# SERVICE BULLETIN

Number: 75-1

Date : 9/6/74

- A. MerCruiser Drive Unit Trail-Out
- B. Reverse Lock Valve Adjustment

Figure 1. Control Valve Styles

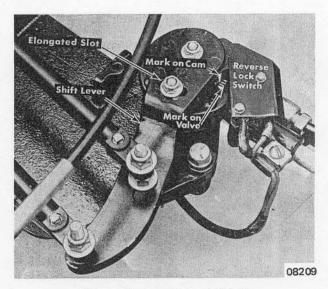
- 1. If the top of the Power Trim pump motor is marked with white paint, the correct control valve (B-48077A3) has been installed.
- 2. If trim pump is not marked, you must check the control valve to ensure that control valve B-48077A3 IS NOT installed before installing kit. Figure 1 shows both styles of control valves. "A" is valve B-66074A3 (note the raised portion). This valve requires kit B-71802A1 to be installed. "B" is valve B-48077A3 (note valve surface is flat). This valve requires NO kit to be installed.

Install new Power Trim Control Valve Kit (B-71802A1) on all MerCruiser units which have B-66074A3 Control Valve. <u>DO NOT INSTALL</u> this kit on any unit which already has the B-48077A3 Control Valve installed.
